SOA / PIN based OLT receiver update

David Piehler, Ruomei Mu
17 July 2007
dpiehler@alphion.com

A request

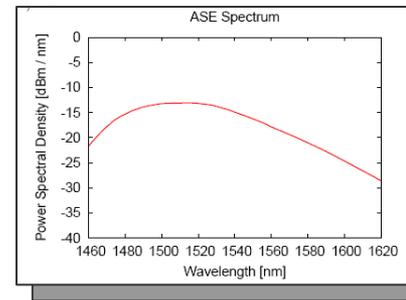
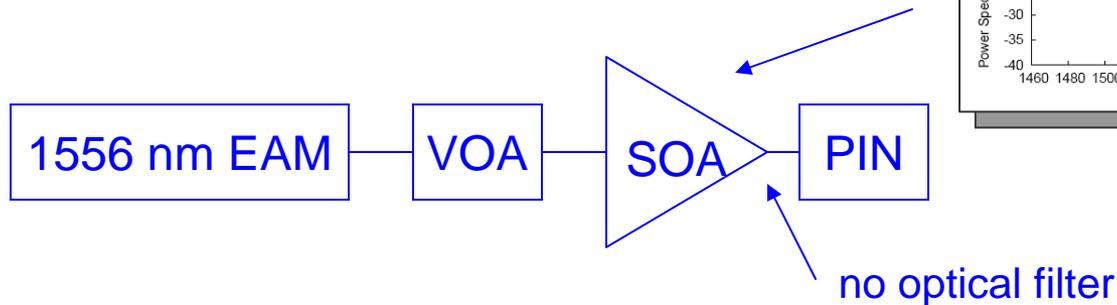
Suzuki-san of NTT suggested in the email exploder.

(1) To provide some results (if possible, both experimental and numerical) of BER curve measurements including BERs below $10E-12$ to confirm whether there are error floors because I think “error floor” means that the SNR does not linearly improve with the optical input power and stay around an insufficient SNR value.

(2) To provide some results of “Q” measurements to experimentally confirm whether there are error floors because I think it is hard (or takes a very long time) to measure sensitivities at low bit-error rates.

We preformed the following experiment

Q measurements are somewhat better than calculation at higher input power

BER measurements are somewhat worse than calculation at higher input power

PDG fluctuation

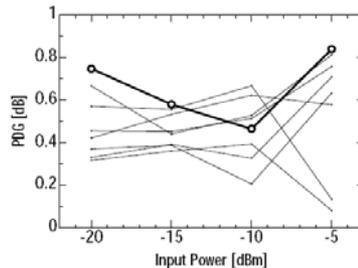
The PDG value depends on input power, injection current and signal wavelength.

Because, it is affected by carrier density in SOA waveguide.

As long as polarization stays below the PDG limit (we believe that +/- 0.50 dB is reasonable, and is met in the above data) There is no problem because PDG is taken into account in the PIN/filter/SOA design.

Gain bandwidth shrinkage

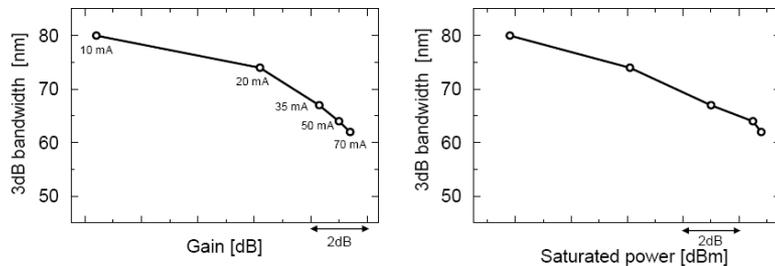
Gain bandwidth shrinks under large gain operating condition.

It is according to band filling effect.

This data was measured by ASE spectrum which bandwidth is almost same as signal gain bandwidth.

It is not unusual that gain bandwidth decrease increasing injection current. However, we propose to operate the SOA at a constant current – therefore gain shrinkage is not an issue
